90-04-06 R1 TEXTRON LYCOMING: Amendment 39-6427 as revised by Amendment 39-6915. Docket No. 89-ANE-21.

Applicability: All Textron Lycoming four cylinder piston engines equipped with a rear mounted propeller governor and external oil line, manufactured prior to January 1, 1990.

To prevent oil line fracture and loss of engine oil, accomplish the following:

Figure 1. Propeller Governor Line Support PART 1

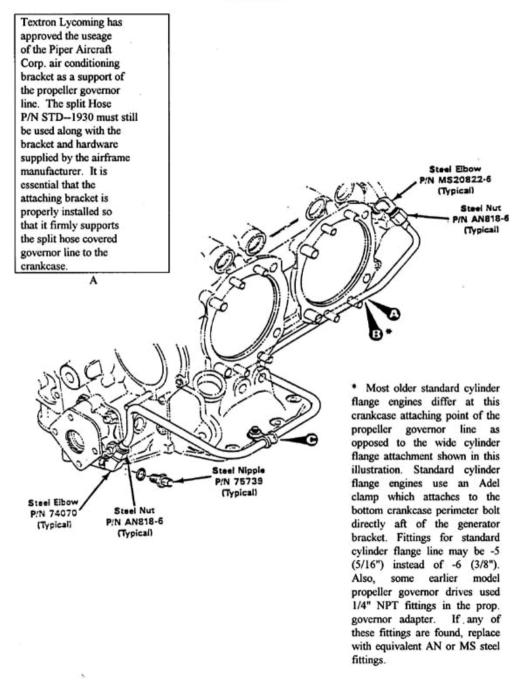
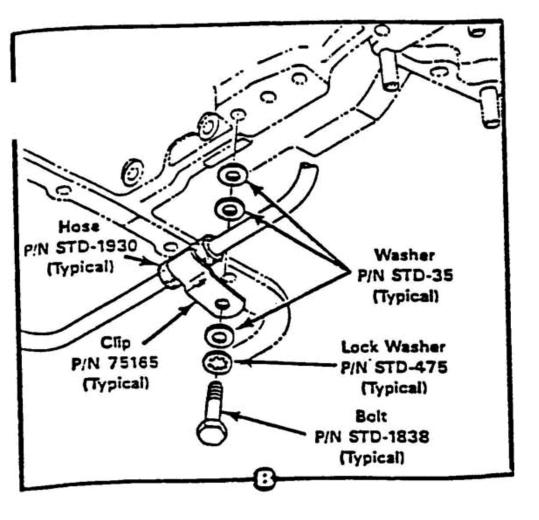
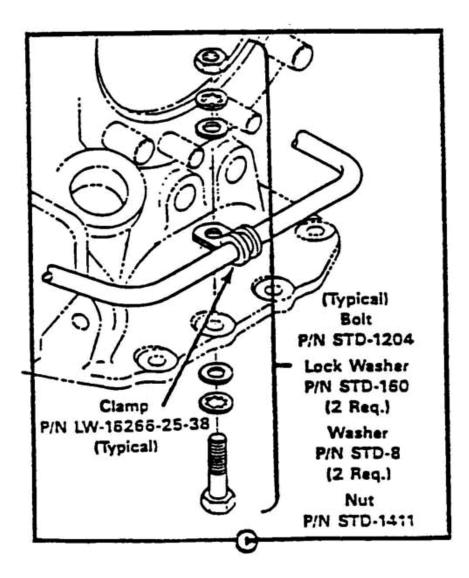
(1) Inspect the propeller governor external oil line for abrasions, cracks, and oil leaks along the length of the line and at the end attachment fittings. Inspect to determine that the two cushion type support clamps or clips are properly installed as shown in Figure 1 of Appendix 1 to this AD, and assure that sufficient clearances exist between the oil line and adjacent components.

(2) If any leaks, chafing, or interference condition exists or if the two support clamps or clips are not properly installed, replace the governor oil line and its attachment end fittings with new parts even though the parts show no visible damage. Refer to Figure 1 in Appendix 1 to this AD, for parts identification, line routing, and location of support clamps or clips. The fittings in the engine case and governor must be replaced if they are damaged or are made of aluminum.

(b) At the next engine overhaul or anytime the governor oil line is removed for any reason, whichever occurs first, but no later than May 1, 1992, remove any governor oil line assembly having integral aluminum connecting nuts and reinstall an oil line assembly with corresponding steel connecting nuts. Replace any engine case/governor aluminum fittings with corresponding steel fittings as shown in Figure 1 of Appendix 1 to this AD.

Figure 1. Routing, Fittings and Clamping Detail

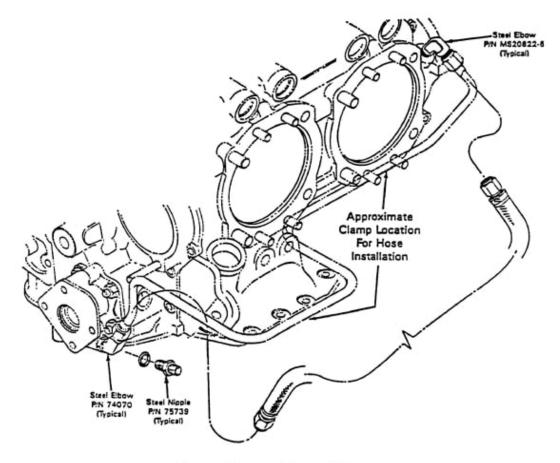
If -5 (5/16") fittings have been installed on some standard cylinder flange crankcase model engines, the propeller governor drive fitting and front crankcase fitting must be changed to the appropriate steel fitting to accommodate the new -6 (3/8") line. When reinstalling new stainless steel tube assembly, appropriate -5 steel fittings must be reinstalled.

IT IS MANDATORY THAT THIS FLEXIBLE HOSE BE REPLACED AT EACH OVERHAUL.

a. Determine proper hose length as required for your particular installation.

b. No sharp bends are permissible. Ascertain that no "kinks" exist while routing and

clamping hose.

c. Hose must not be routed near a heat source, such as any portion of the exhaust system.

d. Hose is to be clamp supported to the engine (not to an airframe component) at a minimum of two locations.

e. No clamping to cylinder head drain back tubes is allowed.

f. After installation is complete, ensure that hose is not pinched. Make certain that engine motion during startup and shutdown does not pull or pinch the hose.
